Application	General Data		
Public hearing and consideration of a	Planning Commission	June 25, 2020	
request to construct a single-family	Hearing:		
dwelling on developed, substandard	City Council	July 7, 2020	
lot.	Hearing:	-	
Address:	Zone:	R-8/Residential Single-Family	
3109 Circle Hill Road			
Applicant:	Small Area Plan:	North Ridge/Rosemont	
Nicole Mayer and Jeff Seibel		_

The applicants, Nicole Mayer and Jeff Seibel request Special Use Permit (SUP) approval to construct a single-family dwelling on a developed, substandard lot at 3109 Circle Hill Road. The existing lot is substandard as it does not meet the R-8 zone requirements for minimum lot width and frontage.

Figure 5 - Rear Elevation

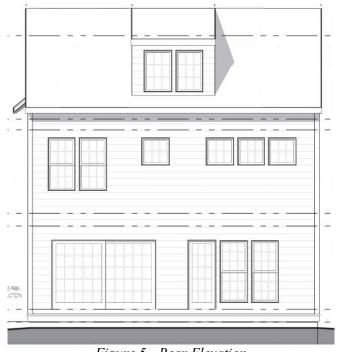
The applicant's proposed dwelling exhibits characteristics typical of Colonial Revival architecture, an appropriate style for this part of the City. Classical columns support the hipped roof front porch which extends about seven feet from the dwelling's front. The front portion of the house would be brick clad. All remaining façades would

Staff supports the applicant's proposed design, finding it in character with this established neighborhood's eclectic feel. The gable roofs of the two distinct sections of the proposed dwelling would echo other roofs along Circle Hill Drive and would harmonize its design with the rest of the street. The dwelling's rear portion sits back 20 feet from the front of the porch, minimizing its height and bulk and their visual impact from the street. The front porch would also function to reduce the dwelling's overall height and bulk impact.

Figure 6 - Proposed Site Plan

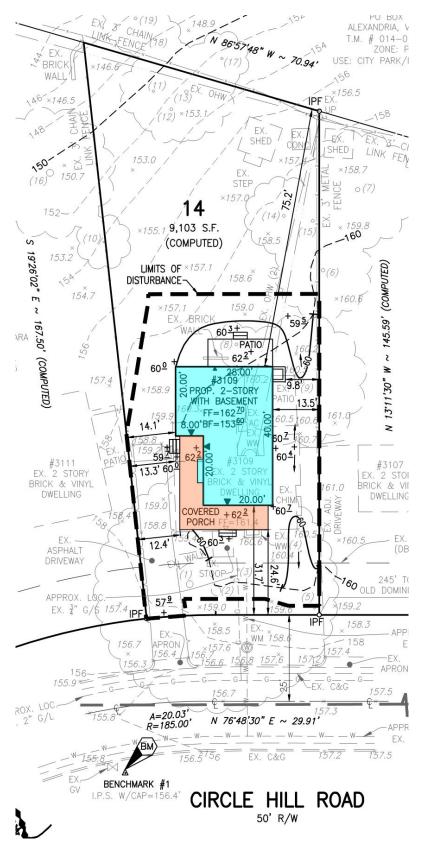
The dwelling would measure approximately 40 by 28 feet with a footprint of about 1,349 square feet. It would provide a front yard of 31.7 feet; east and west side yards of 12.4 and 13.5 feet, respectively, and a rear yard of 72.3 feet. Figure 8, below, shows the proposed site plan.

The applicant's proposal would be compatible with neighborhood character in terms of bulk. The proposed dwelling would be well below the maximum FAR permitted for the subject property. It would also provide setbacks in excess of the minimum required by the R-8 zone. Notably, the proposed dwelling would provide a significantly larger west side yard than the existing dwelling. This separation would provide more open space between the subject property and its neighbor at 3107 Circle Hill Drive.

TREE AND VEGETATION
SURVEY & PROTECTION PLA

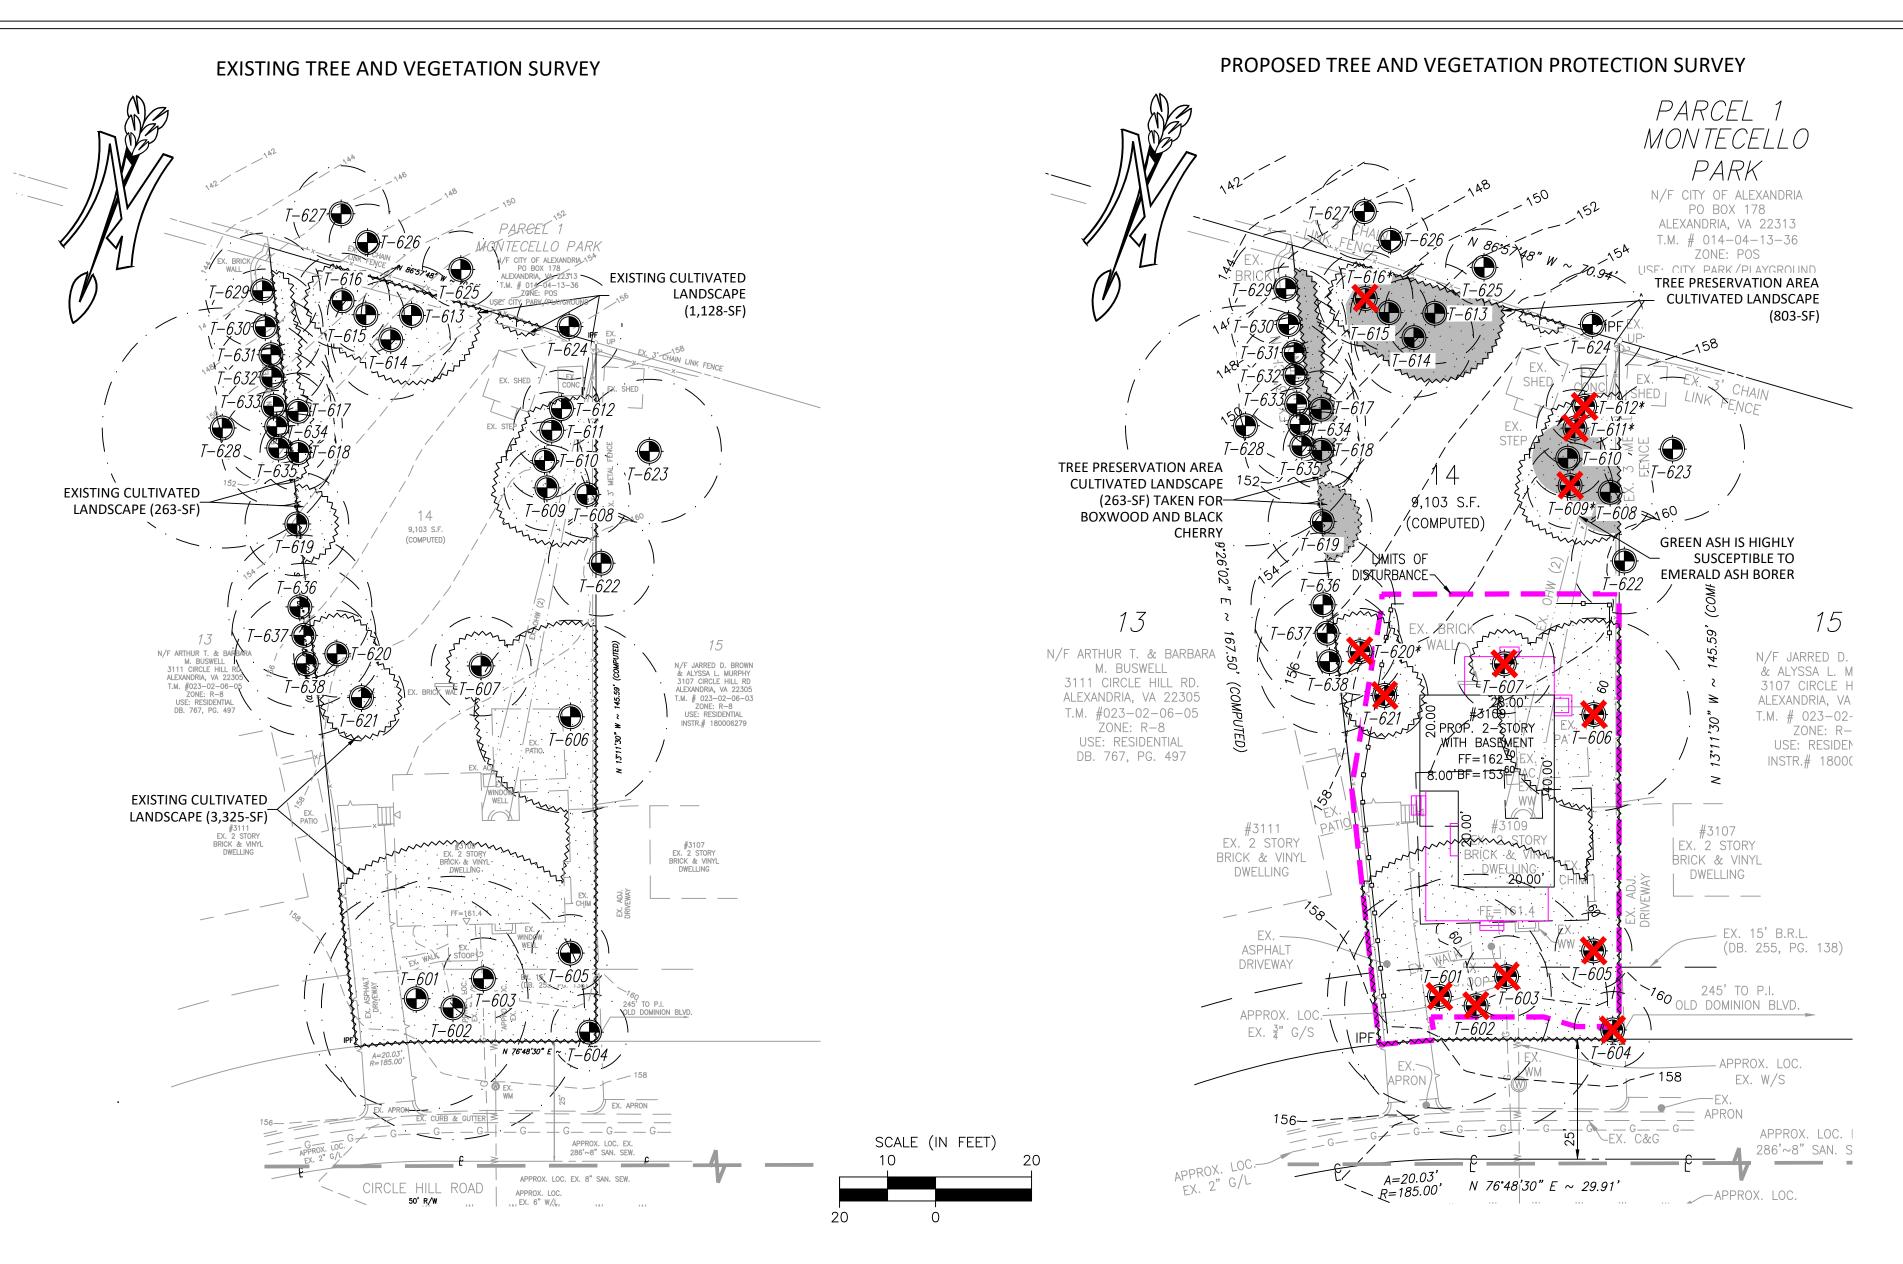
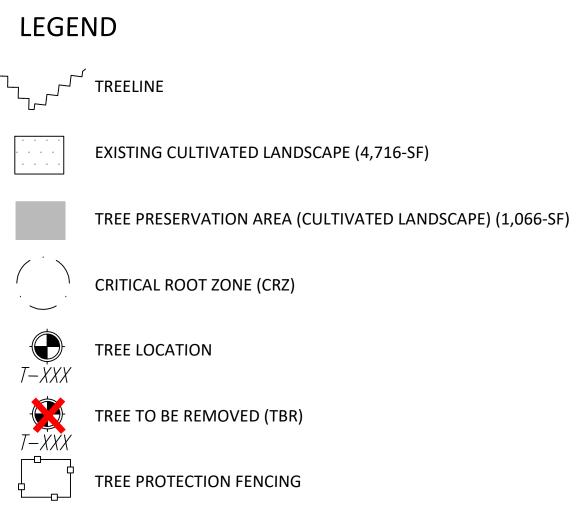
Staff received a statement dated June 8, 2020 from North Ridge Citizens' Association (NRCA) endorsing the applicants' proposal. The statement has been included with this report. NRCA is concerned about loss of canopy trees and strongly encourages a 50 percent canopy coverage. They also recommend that native canopy species should be planted to replace existing, mature trees.

Our review of the plans included a careful check of how the new foundation and driveway would affect several mature trees on the property. Two white oaks and one red maple are within the designated construction area and are slated for removal by the consulting arborist. Jeff and Nicole intend to work with the builder to try to save two of these trees, if possible. In keeping with our construction guidelines for the neighborhood, NRCA strongly endorses this effort to save mature native trees. Per our guidelines, we strongly recommend that three native canopy species be planted to replace any mature native tree lost due to the construction project. NRCA advocates for a minimum 50% canopy coverage, not including understory trees and shrubs. Recommended examples include the indigenous canopy trees of Monticello Park - oaks, hickories, Nyssa sylvatica and tulip poplars. These blend into the existing canopy of the park and bring long term benefits to the owners and the neighborhood, as well.

To address these concerns, staff recommends Conditions #2 and #3, which would require 40 percent canopy coverage and that replacement trees shall be high-quality, long-lived native canopy trees. Staff recommends the 40 percent canopy coverage as the maximum the subject property could provide. Higher canopy coverage percentages would likely compromise the healthy growth of newly planted trees.
